Deviation From Design

DfD : DfD-0005

**Taran Laval – SAAA Builder 7417
Van's Aircraft RV7 - 73918**

RH HS404-HS710-HS405 Hole Elongation

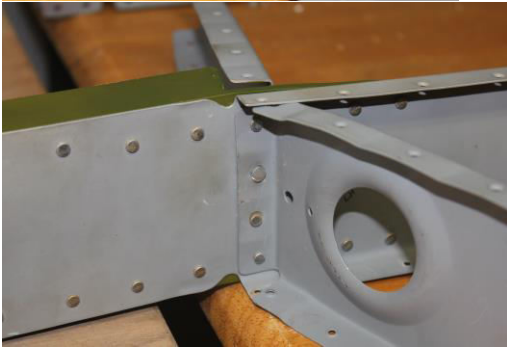
During removal of the RH HS404 the upper rivet hole become elongated.

Drilled upper RH HS404 hole to 5/32 and installed a – 5 rivet.
